Bulletin No.: PIP5198

Service Bulletin

Subject: Instrument Panel Cluster (IPC) Warning Lamps And/Or MIL Are Illuminated Diesel Exhaust Fluid (DEF) Message Displayed Various DTCs Set (Inspect Wiring Harnesses for Chafing)

Models: 2015 Chevrolet Silverado
2015 GMC Sierra
Equipped with 6.6L Duramax™ Diesel Engine RPO LML

3825841

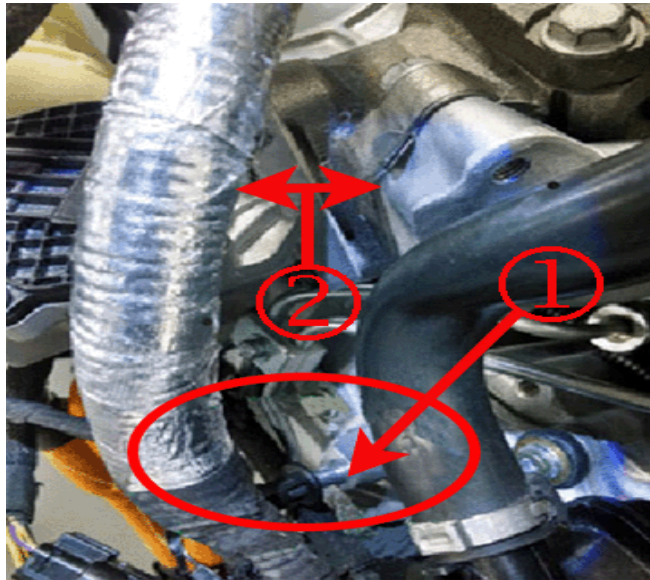
It is critical that the wiring harness retainer is fully seated onto the stud on the driver's side rocker cover. This retainer is tied to the harness and is located underneath the charged air cooler (CAC) inlet pipe near the #4 fuel injector. Proper routing and securing of the harness ensures there is clearance between the harness and the EGR valve.

1. Wiring harness retainer fully seated onto the stud on the driver's side rocker cover.
2. Proper clearance between the harness and the EGR valve

3825844

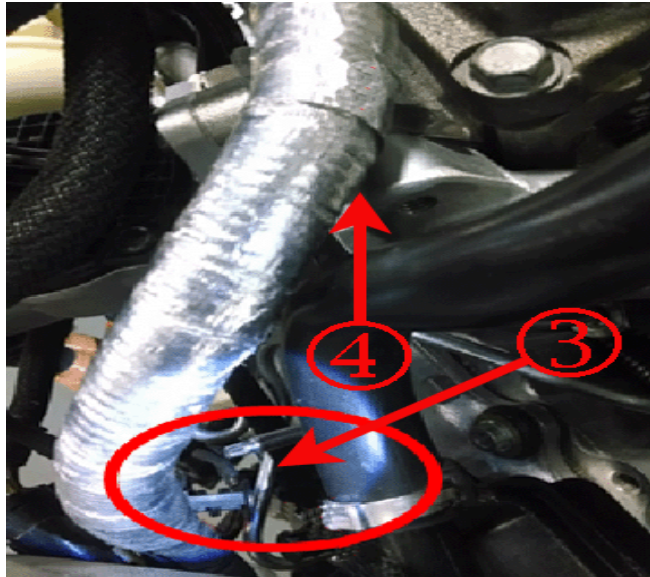
3. Wiring harness retainer NOT fully seated onto the stud on the driver's side rocker cover.
4. IMPROPER clearance between the harness and the EGR valve.
Bend the tab of the EGR gasket over to prevent a re-occurrence.
